**The Great Grid Upgrade**

Norwich to Tilbury

2022 Non-statutory Consultation Feedback Report

June 2023

Figure 3.28- Basildon and Brentwood section map

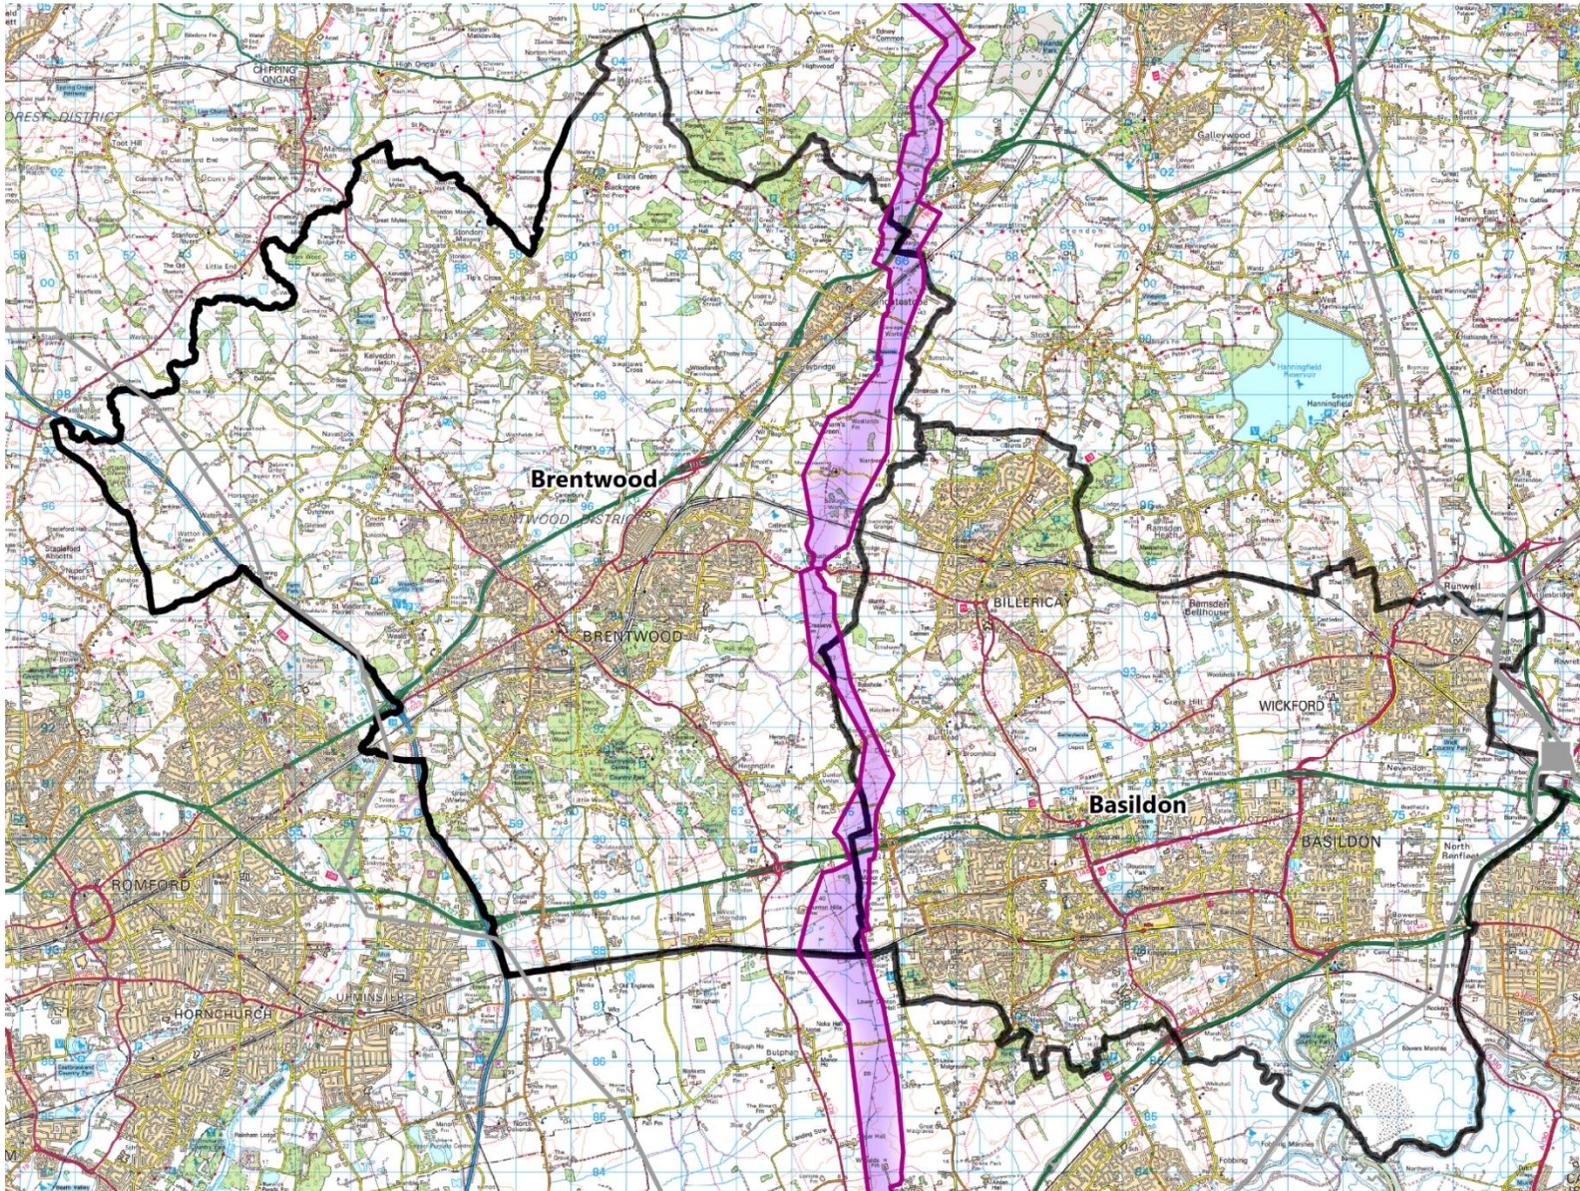
Ref no.	Summary of matters raised	National Grid's response
Agricultural land		
3.16.1	The Project will be taking away valuable agricultural land / disrupt farming operations	National Grid recognises that there is the potential for impacts. We look to limit the impact on agricultural land through careful and considered routeing and siting of infrastructure and through consultation with affected landowners. We are and will continue to work with all landowners including farmers who may be affected by the proposals to understand the potential impacts on their operations and to work with them as the Project is developed. We will seek to work with the farming community to limit disruption where practicable. This includes providing prior warning of works which may result in the need to move livestock. Compensation claims for disturbance are considered on a case-by-case basis. Particular agricultural matters can also be written into voluntary land agreements.

Figure 3.29- Thurrock section map

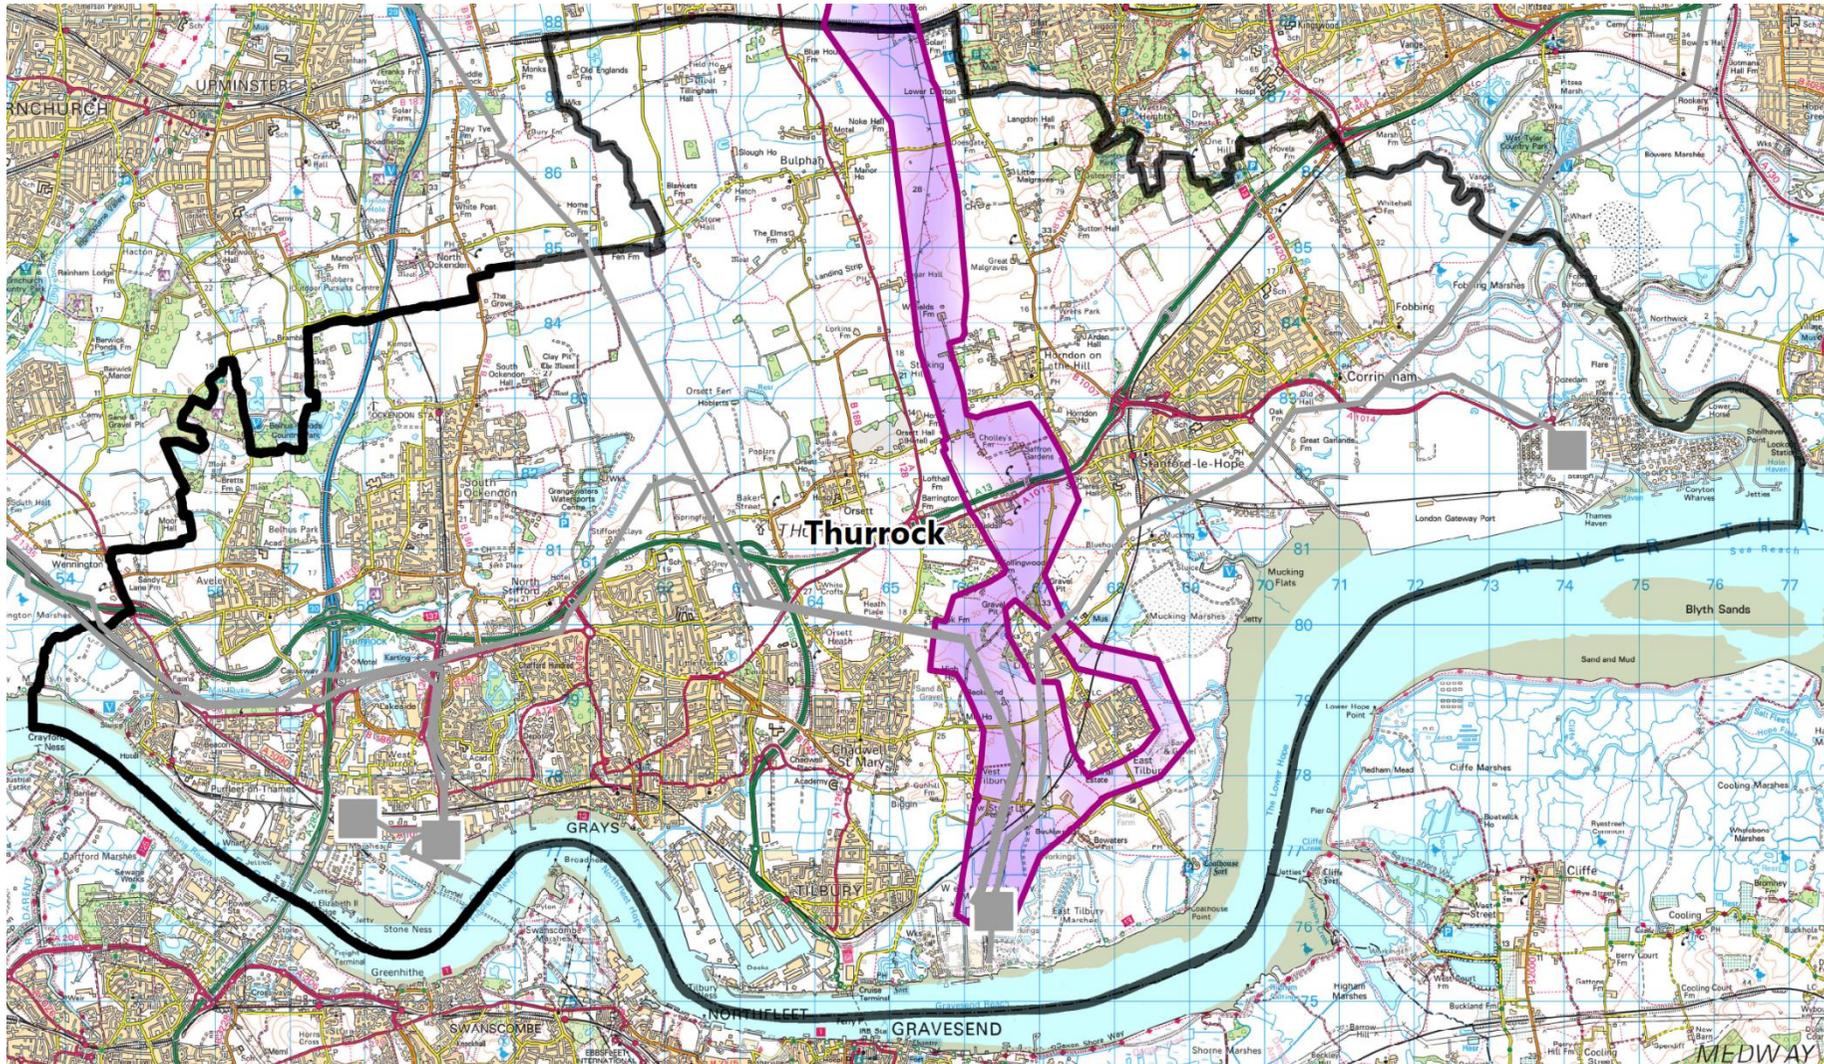
Ref no.	Summary of matters raised	National Grid's response
Agricultural land		
3.17.1	The Project will be taking away valuable agricultural land / disrupt farming operations	National Grid recognises that there is the potential for impacts. We look to limit the impact on agricultural land through careful and considered routeing and siting of infrastructure and through consultation with affected landowners. We are and will continue to work with all landowners including farmers who may be affected by the proposals to understand the potential impacts on their operations and to work with them as the Project is developed. We will seek to work with the farming community to limit disruption where practicable. This includes providing prior warning of works which may result in the need to move livestock. Compensation claims for disturbance are considered on a case-by-case basis. Particular agricultural matters can also be written into voluntary land agreements.
